EDGERTON PLANNING COMMISSION AGENDA  
SPECIAL SESSION  
Edgerton City Hall  
October 18, 2016  
7:00 PM

To: Edgerton Planning Commission  
 Fr: Kenneth Cook, AICP, CFM, Community Development Director  
 Re: PP2016-03 Preliminary Plat for Logistics Park Kansas City Phase III

To: Edgerton Planning Commission  
Fr: Kenneth Cook, AICP, CFM, Community Development Director  
Re: Application PS2016-03 for Preliminary Site Plan for Logistics Park Kansas City Phase III, First Plat

# Logistics Park Kansas City Phase III Preliminary Site Plan

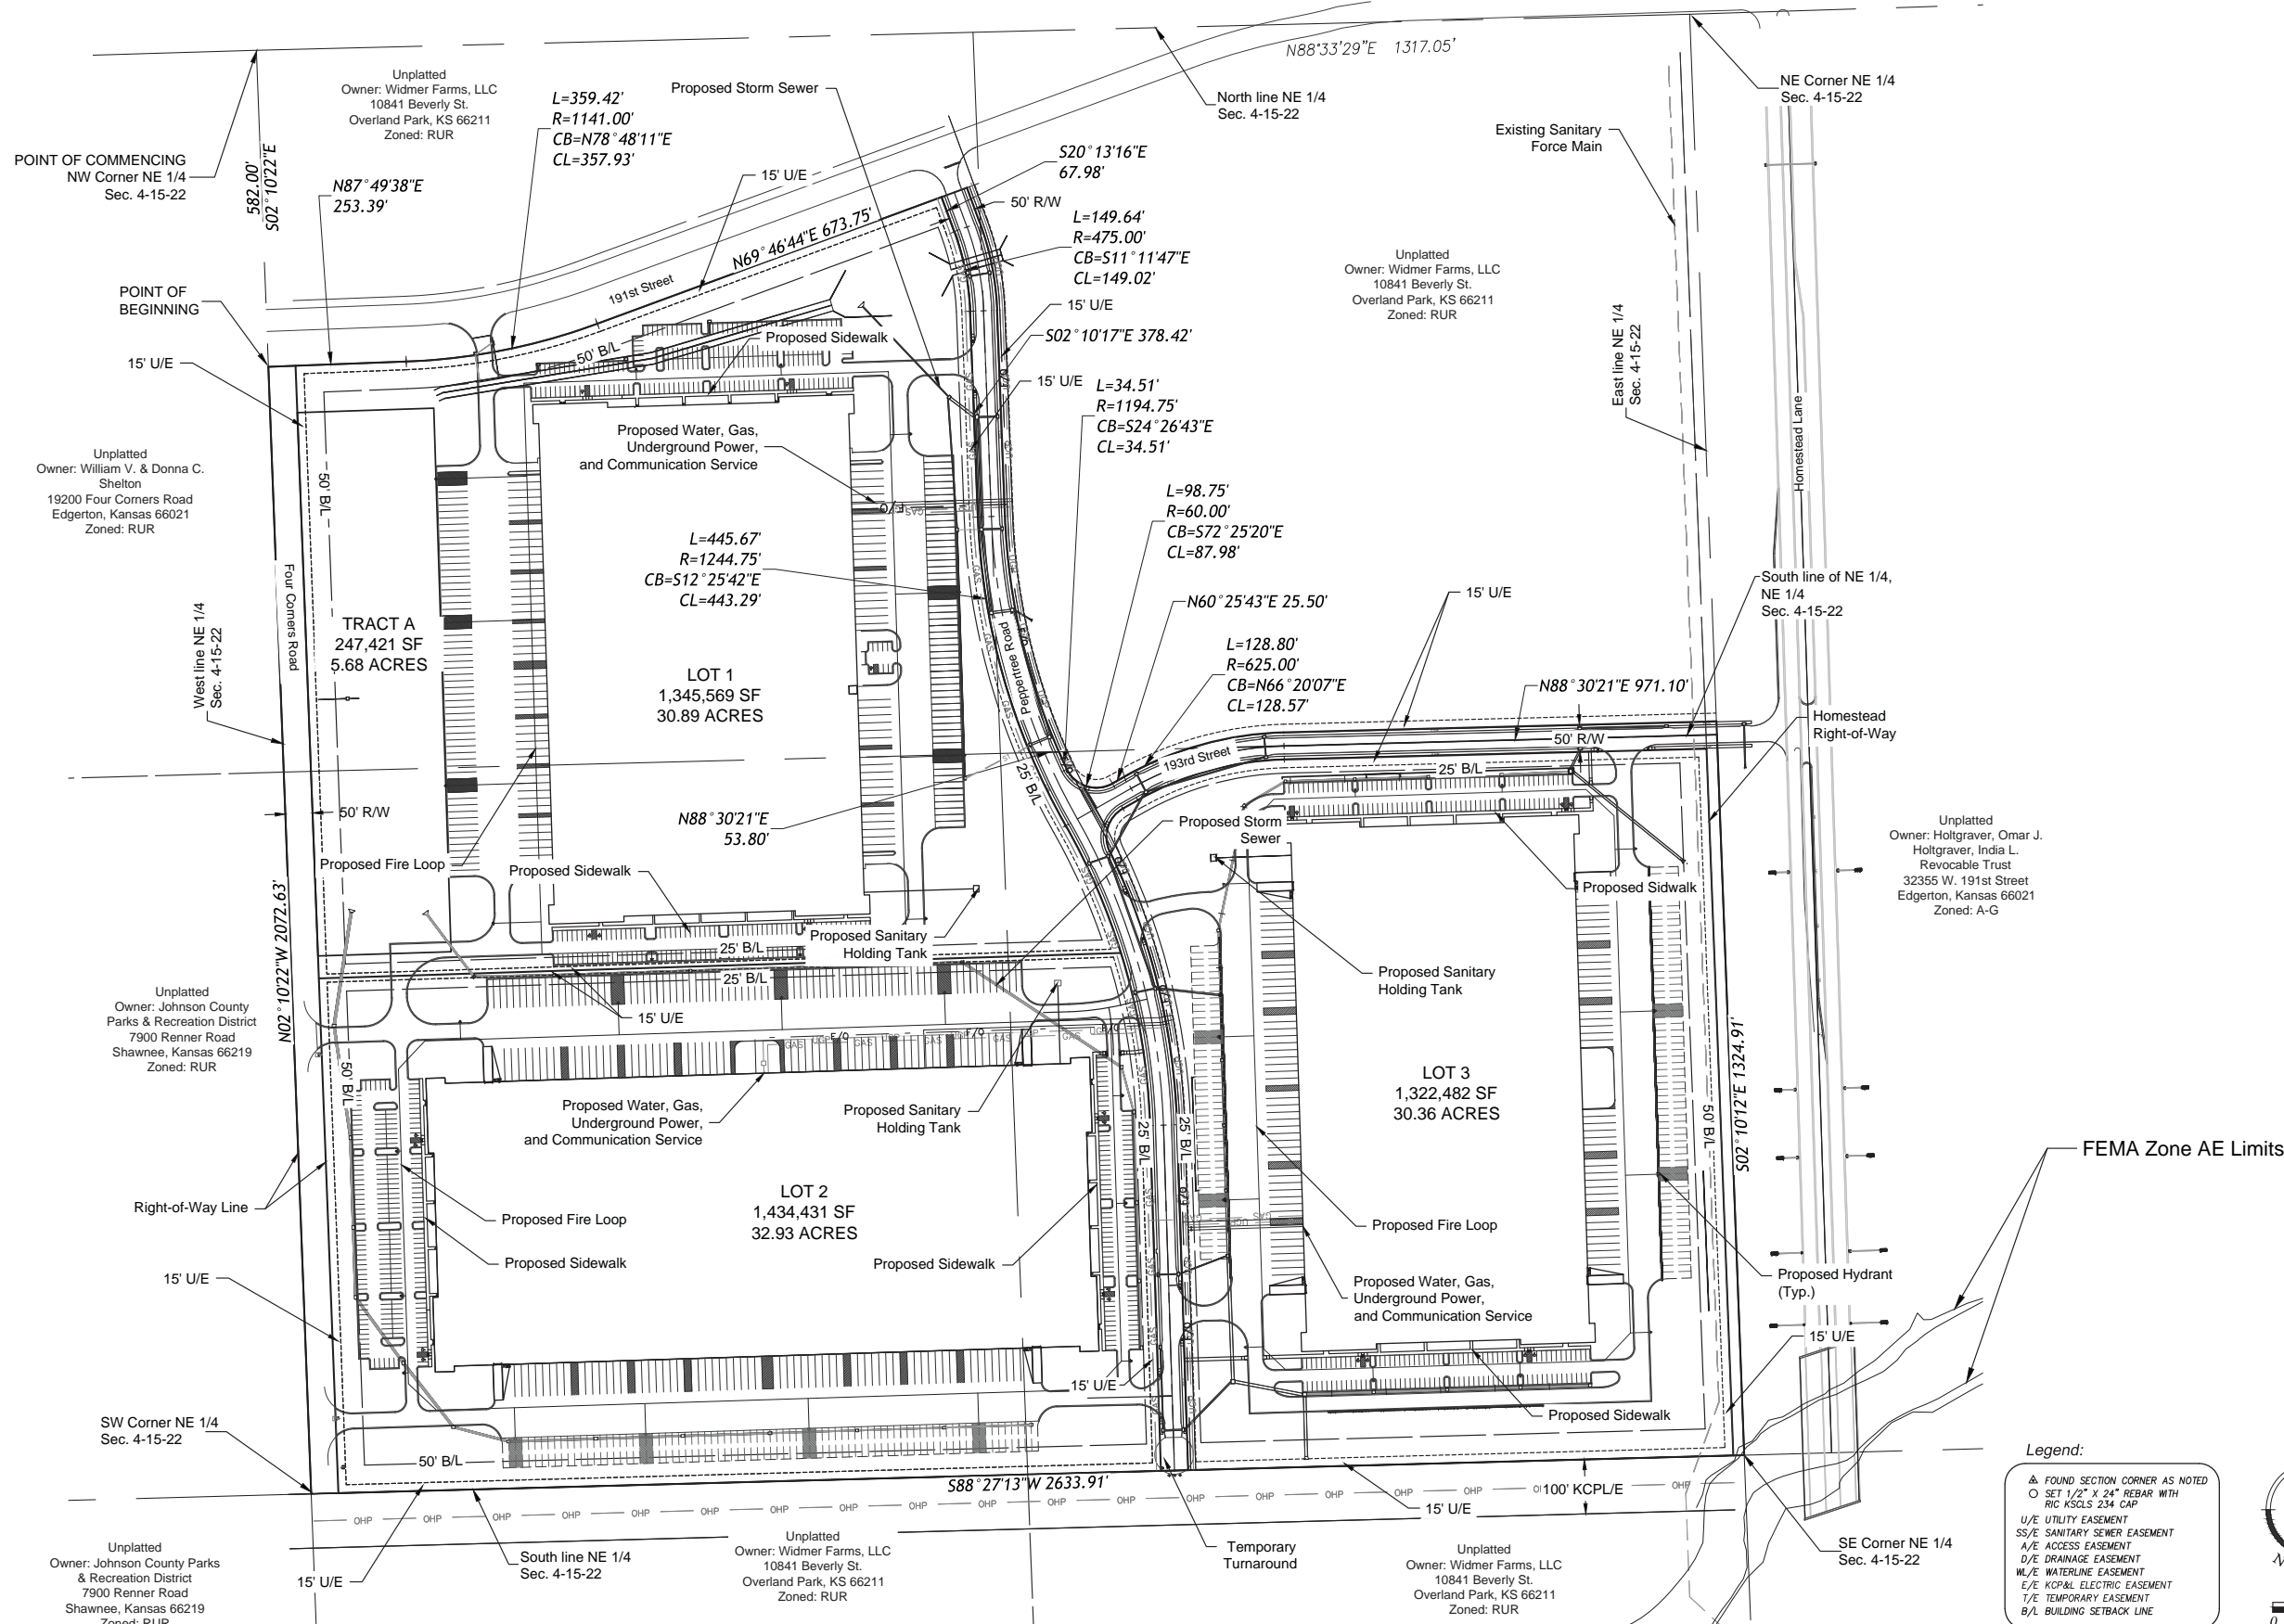
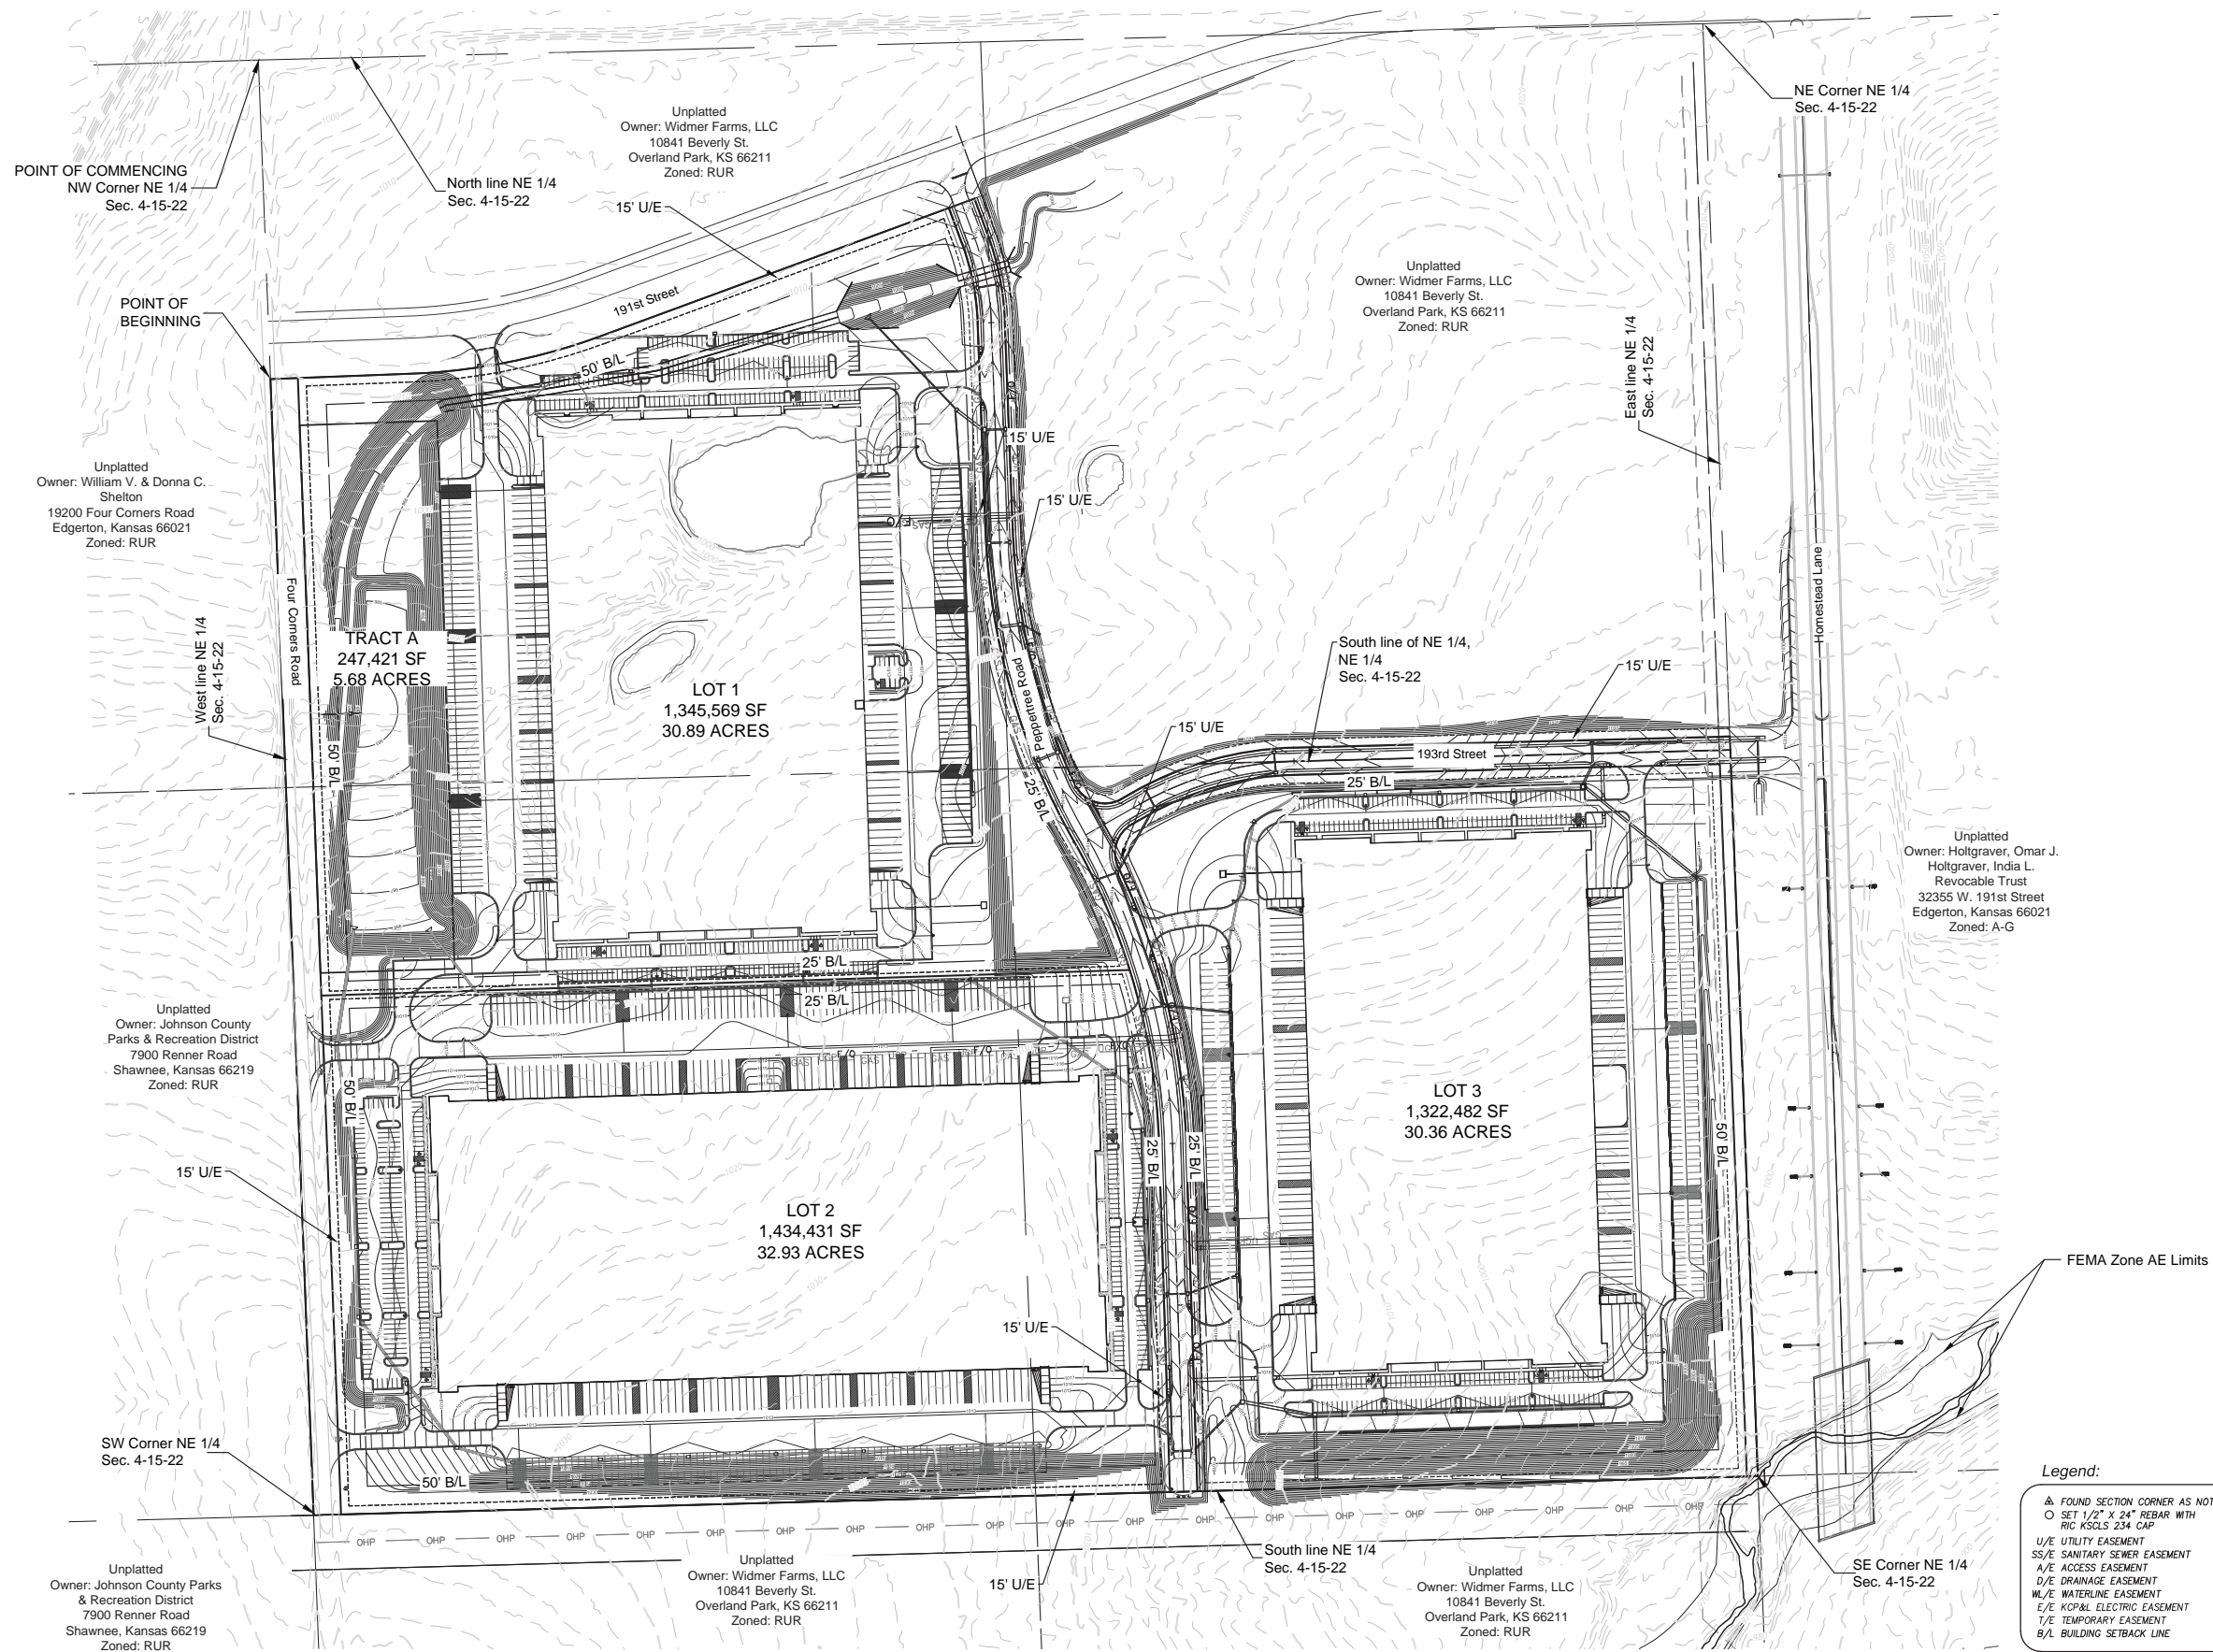
2. A legal description; and current zoning. **Preliminary Plat complies.**
3. Names of: Applicant, Subdivision & Streets. *Staff does suggest that the name of the road be discussed to determine if a different name should be used. While a portion of the alignment does appear to closely align with Pepper Tree Lane staff would ask if it would be a better idea to provide a different name on this section so that there may be less confusion on which portions are more residential or industrial. Johnson County Emergency Management has suggested the name of Essex Street to match the county's naming convention. **Needs Discussed By Planning Commission.***

11. Complete outline drawing of all boundaries, lots, and streets, together with courses, distances and areas. Boundaries must be shown as solid lines and all easements as dashed lines. *The current plan of finance for LPKC includes the removal of Four Corners Road. The applicant is continuing to work with Staff on options for providing access to this side of the site and which may require minor changes when the Final Plats for these lots are submitted dependent upon decisions by the City Council in regards to this road. **Preliminary Plat complies.***

13. Proposed location of streets, sidewalks, sanitary sewers, storm water sewers, water mains, and fire hydrants. Plat must show that the water distribution system and the sanitary sewer collection system touch upon each lot, or in an easement appurtenant to each lot. *While proposed streets, fire loops and storm sewers are shown, no other information has been provided on the plat (such as water mains & Fire Hydrants in ROW). The streets that are shown as being developed as part of this subdivision where dedicated by a separate instrument and said document should be referenced on the plat (Book & Page). Staff would suggest that the name of the North-South Road be changed to reduce any confusion which might occur and cause trucks to turn down the residential road located on the South side of 199<sup>th</sup> Street. Johnson County Emergency Management has suggested the name of Essex Street to match their normal naming conventions. It would appear that additional easement will be required for the temporary turnaround and it also appears that this turnaround might currently be shown as extending onto the adjacent property to the South. A Book & Page*

*It is also staff's understanding that a sanitary sewer pump station may be required as part of the development of this property and should possibly be shown on the plan. It may be that the Sanitary Sewer Master Plan is not far enough along in order for this to occur and such dedication may be needed at a future time. **Update Preliminary Plat.***

1. Rights-of-way must conform to the current standards of the American Public Works Association, and greater widths may be required by the Zoning Administrator after preliminary review; utility easements must be a minimum of fifteen (15) feet wide or, 7.5 feet for appurtenant utility easements on interior lots. Street lighting and fire hydrants must be indicated in areas planned for residential use. Cul-de-sacs are limited to 800 feet in length. *The proposed North-South street currently dead-ends and a temporary turnaround is shown. The drawing also proposes the use of Four Corners for access to the site although the current plan of finance has specified that Four Corners was to be removed. Staff is continuing to have discussions on this item and changes to the plans may be needed when Final Plats are submitted for Lots 1 and 2. **Staff will provide an update to this item at the meeting.***

- A storm water study has not been provided for the entire area being platted but is typically required as part of a Final Site Plan
- Access Restriction should be shown adjacent to Homestead Lane on Lot 3 as no additional access points will be granted.

1. All Preliminary Plat requirements of the City listed above shall be met or addressed.
2. Final Plats for Lots 1 and 2 may require modifications as Four Corners Road is currently anticipated to be removed.
3. Preliminary plat be approved for a one-year period and shall be extended for an additional year upon the approval of a final plat for the same parcel of land or any part thereof. If a final plat is not approved for a portion or all of the land covered under the preliminary plat within one year, the preliminary plat shall be ruled null and void. The Planning Commission upon submittal and approval of a written request may grant a one-year extension on the approval of the preliminary plat.
4. All infrastructure requirements of the City shall be met.
